REQUEST FOR INFORMATION DATE: June 02, 2016 NO.: RFI-144

Project Name: 15051-Webster University Interdisciplinary Science Building Project No.: 15051

Subject: 2nd Floor Underfloor Fin Tube Radiation

1 LEVEL 02 - AREA B - MECHANICAL PLAN
1/8" = 1'-0"

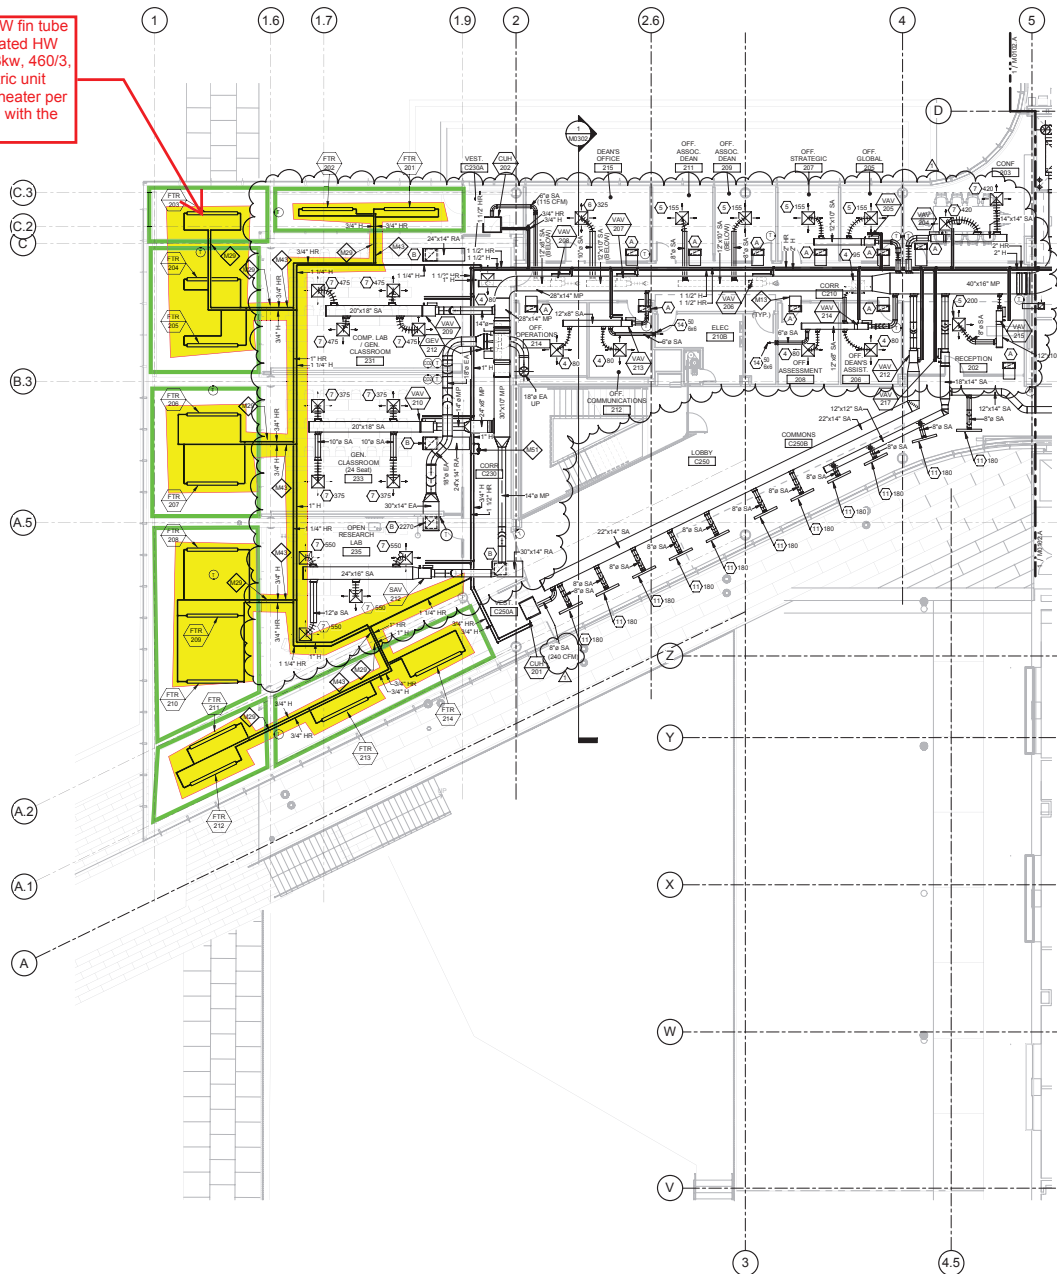
Can the underfloor HW fin tube radiation be eliminated and replaced with seven (7) electric plenum rated unit heaters?

Suggestion: We propose to replace the hot water radiation in the 2nd floor overhang with electric unit heaters due to the freeze, burst and water damage potential. This recently occurred in the St. Louis area where a small controls glitch prevented the control valve, serving the fin tube, from opening and caused the pipes to freeze and burst resulting in extensive water damage. By replacing the hot water piping with electric heat, the threat of water damage is eliminated. There are many variables that could cause this piping to freeze, system glitch, control valve failure, future controls programming changes, etc..

This proposal includes seven (7) 3kW, plenum rated, electric unit heaters to replace the HW fin tube and associated piping. Unit heaters will come with local thermostat control and can be set to the desired setpoint for the underfloor heat.

Proposal to replace HW fin tube radiation and associated HW piping with seven (7) 3kw, 460/3, plenum rated electric unit heaters. One (1) unit heater per "pocket", highlighted with the green box.

The proposal of replacing the fin tube radiation with electric plenum rated unit heaters has been reviewed by the WTA, Cannon, and Webster University and has been determined to be unacceptable. Please proceed with the originally designed fin tube radiation system. - PJG
